### **Process Sheet**

Customer Job Number : CU-DAR001 Dart Helicopters Services

**Drawing Name: LUG**

D412-711 VRF Lug

DESIGN	DRAWN BY	DART AEROSPA HAWKESBURY, ONTARIO,	
CHECKED	APPROVED	DRAWING NO.	REV. A
		D3589	SHEET 3 OF 4
DATE		TITLE	SCALE
07.01.05		ARM LATCH ASSEMBLY	1:1

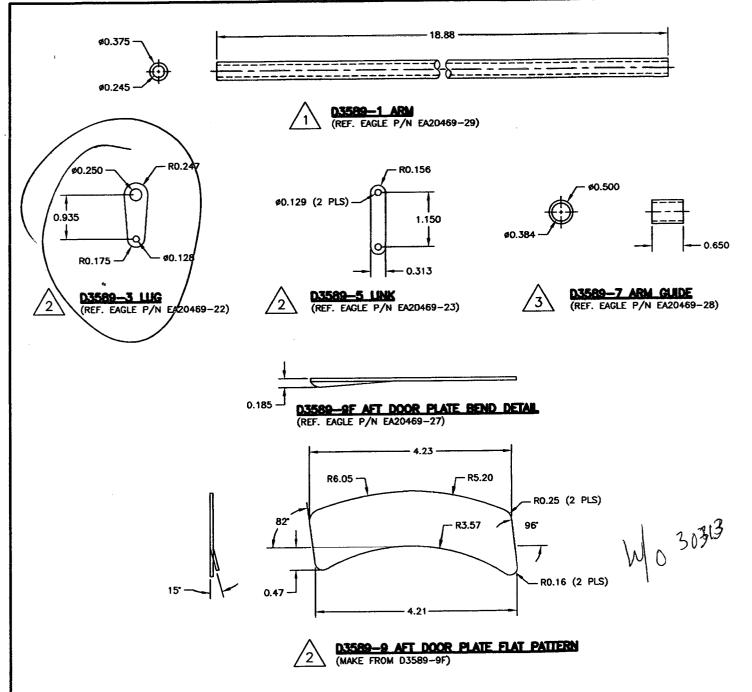
Material on the drawing is 4130 Steel but Dan need 2 to be made out of AISI 304 SS.
